ANCHOR BOLT SETTING PLAN
(BOTTOM OF BASE PLATE ELEVATION: (-1'-10") (U.N.O)
(REF:S1.1)

07/24/2020			ISSUE FOR APPROVAL
DATE	NO.		DESCRIPTION
REVISIONS

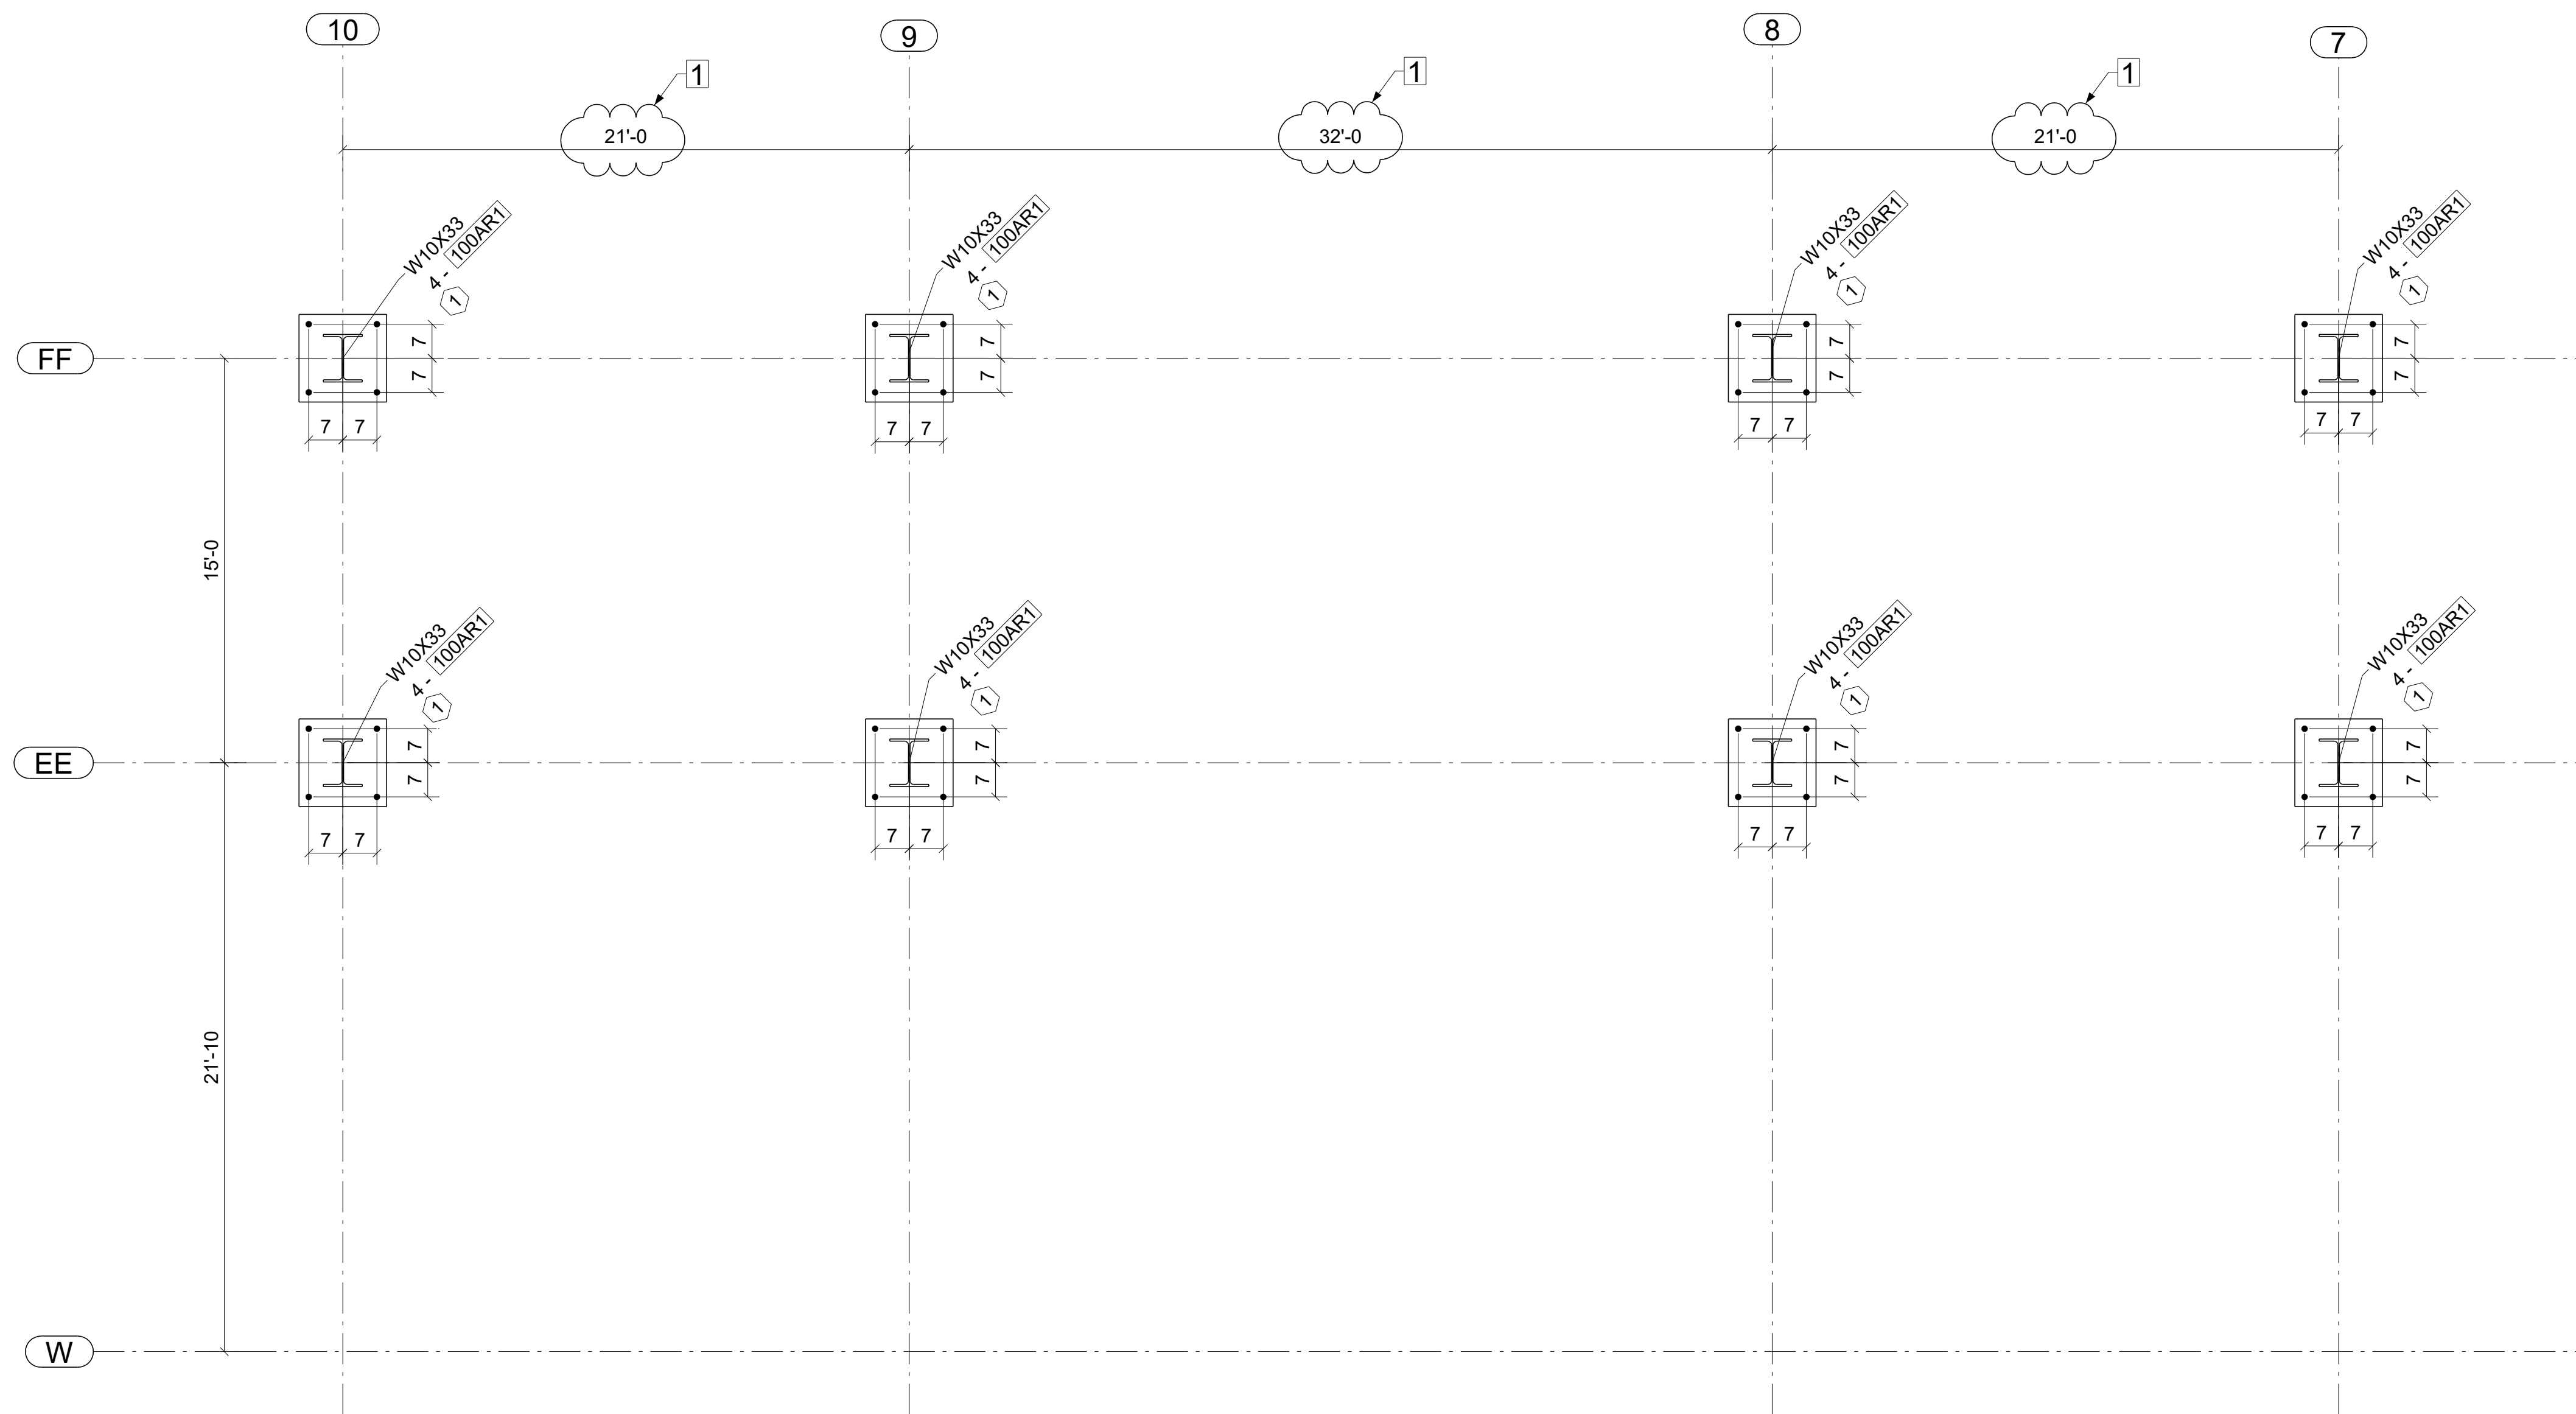
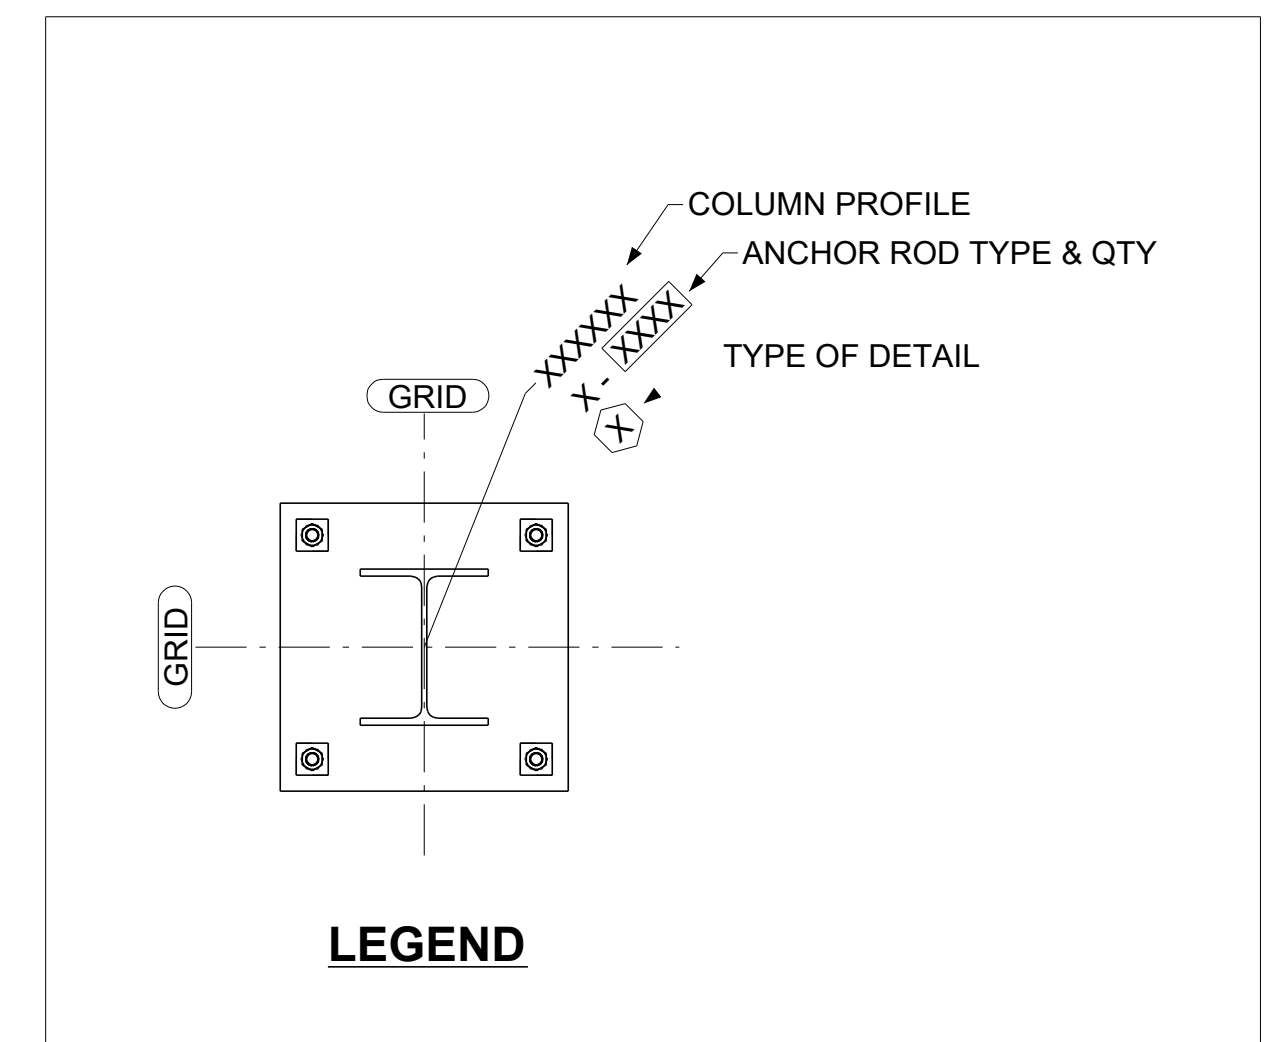
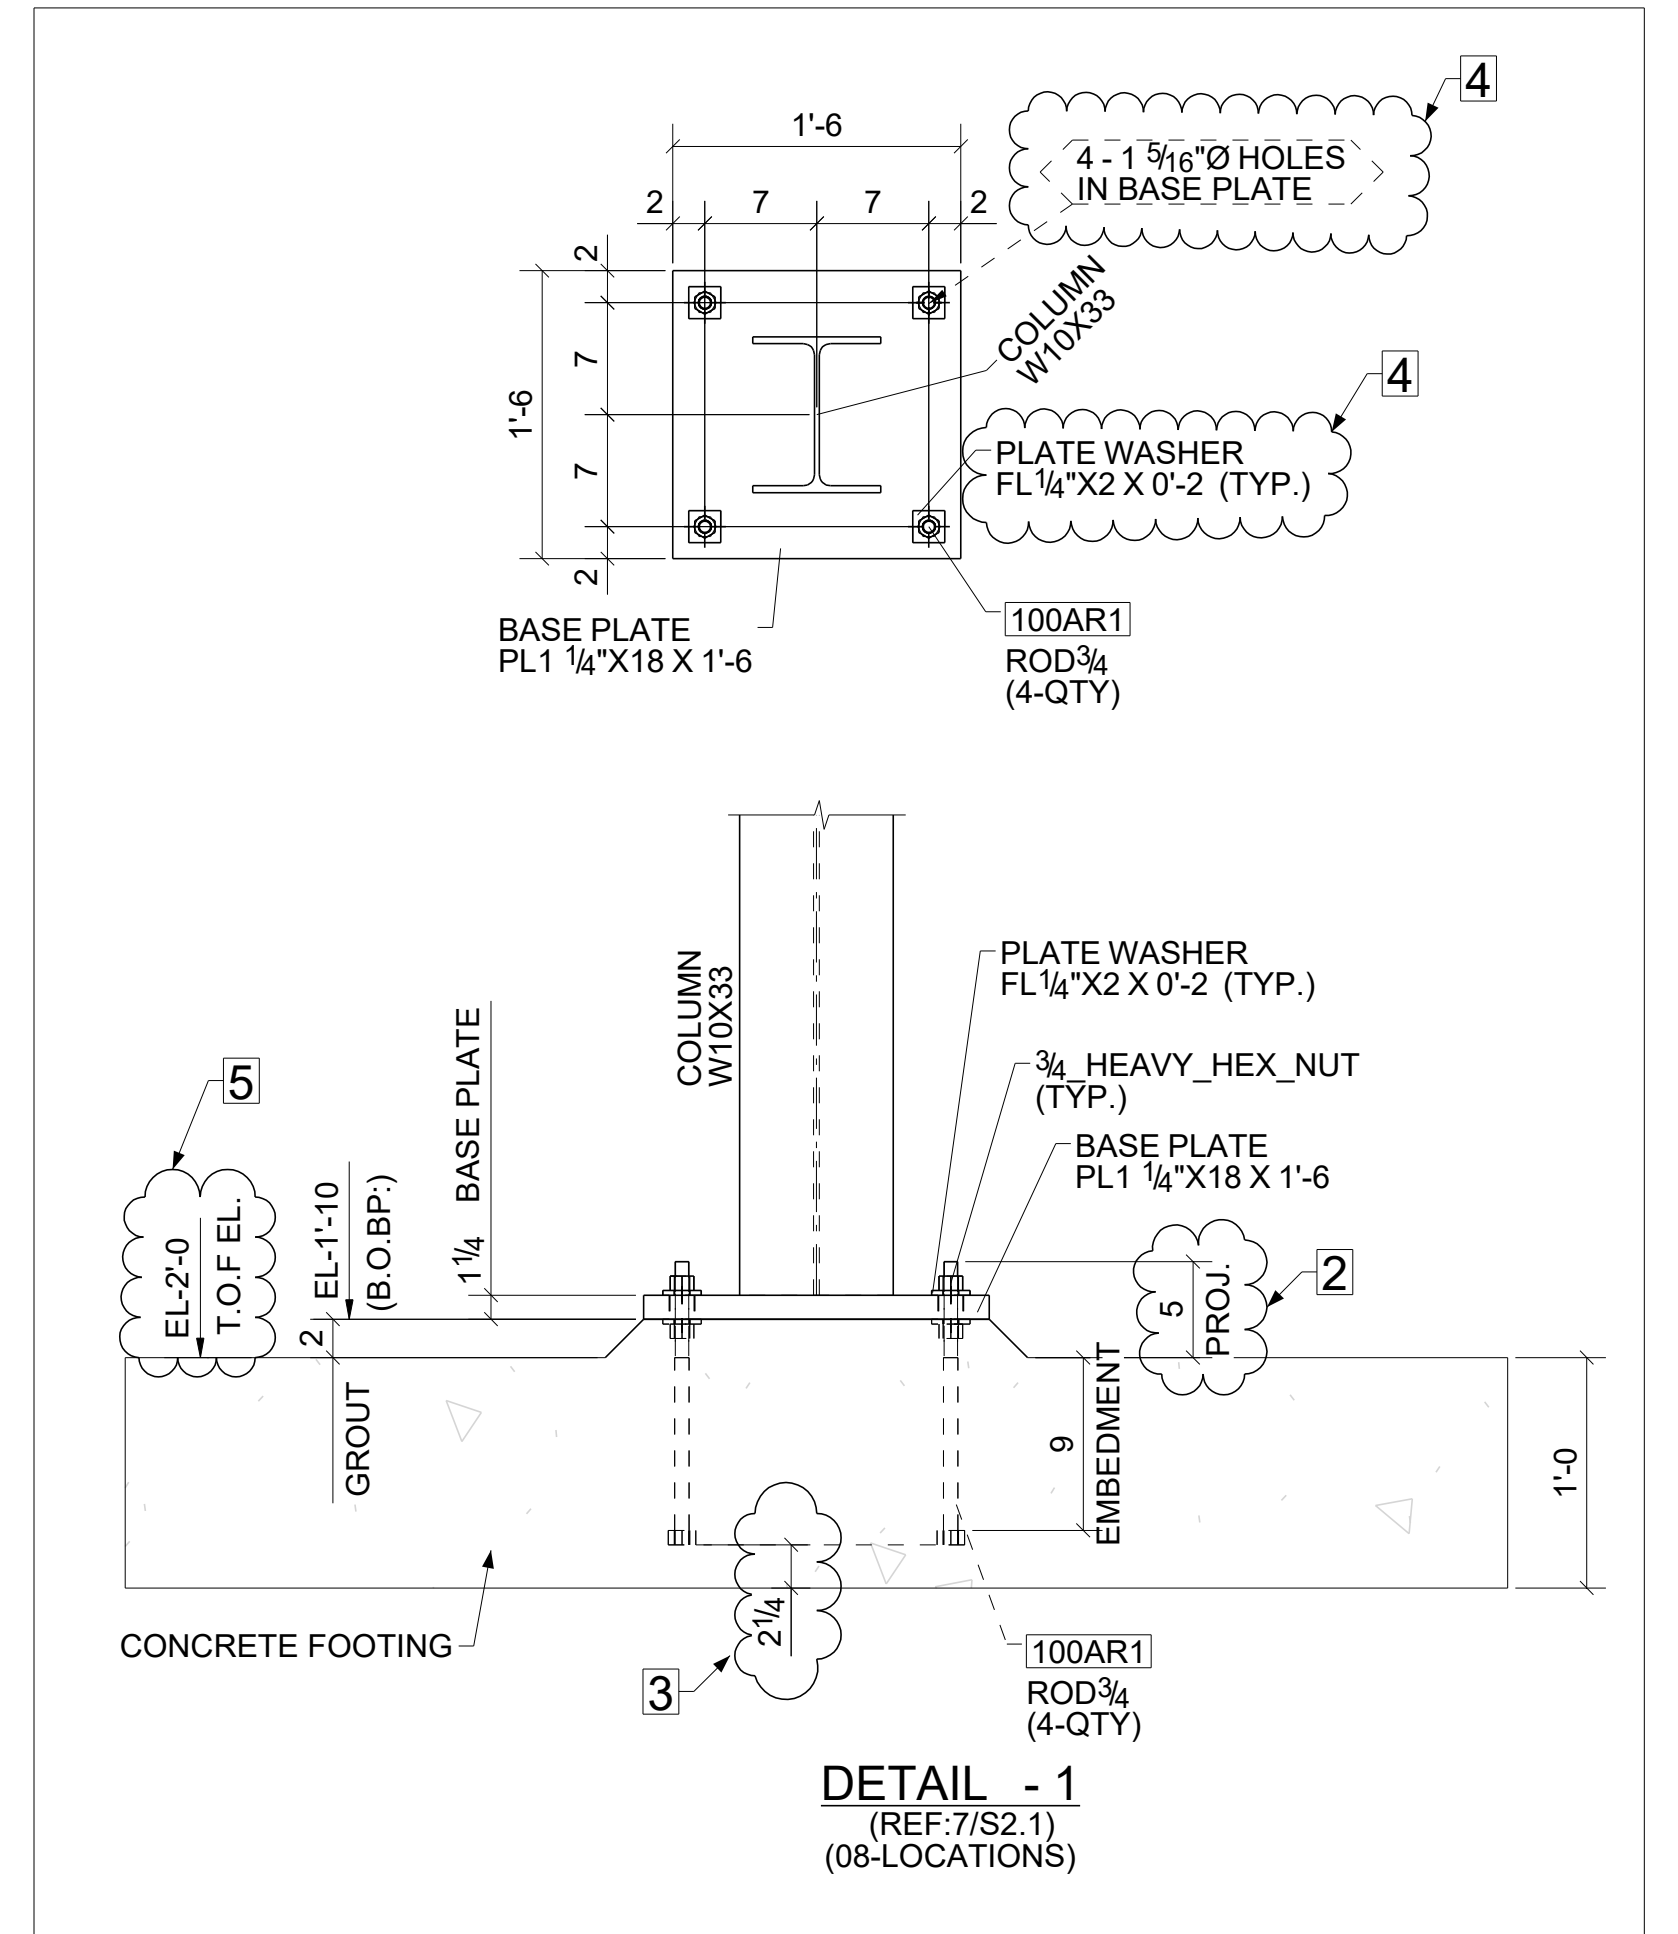
- 1 THE CLOUDED GRID DIMENSIONS ARE INDICATED AS "FIELD VERIFY" IN STRUCTURAL DRAWINGS. HENCE PLEASE VERIFY AND CONFIRM THE CLOUDED GRID DIMENSIONS FOLLOWED.

- 2 WE HAVE FOLLOWED THE PROJECTION DIMENSION AS 5". PLEASE REVIEW AND CONFIRM.
- 3 THE SCHEDULED FOOTING DEPTH IS 1'-0" PER 5/S2.1. IF WE FOLLOW 9" EMBEDMENT AS SHOWN IN 7/S2.1, WE ARE GETTING 2 1/4" CLEAR DIMENSION FROM BOTTOM OF ANCHOR ROD TO BOTTOM OF FOOTING. PLEASE REVIEW AND CONFIRM WHETHER THE FOOTING DEPTH CAN BE INCREASED OR ADVISE.

- 4 WE HAVE FOLLOWED ANCHOR BOLT HOLES IN BASE PLATE AS 1 5/16"Ø WITH "PL 1/4X2X2" SIZE PLATE WASHERS ACCORDING TO AISC 15TH EDITION (TABLE 14-2). PLEASE REVIEW AND CONFIRM.

- 5 WE DID NOT FIND THE TOP OF FOOTING ELEVATION IN STRUCTURAL FOUNDATION PLAN NOTES S1.1. BUT PER 6/S2.1, WE HAVE FOLLOWED THE TOP OF FOOTING ELEVATION AS -2'-0". PLEASE REVIEW AND CONFIRM OR ADVISE OTHERWISE.

- 6 WE ARE ASSUMING THAT THE WHOLE PROJECT WILL BE FIRE PROOFING AND FOLLOWING THE PAINT DETAILS AS " NO PAINT" WITH "SSPC SP3" SURFACE PREPARATION EXCEPT FOR ROOF SCREEN WALL SUPPORT STEEL. PLEASE REVIEW AND CONFIRM OUR ASSUMPTIONS ARE CORRECT.
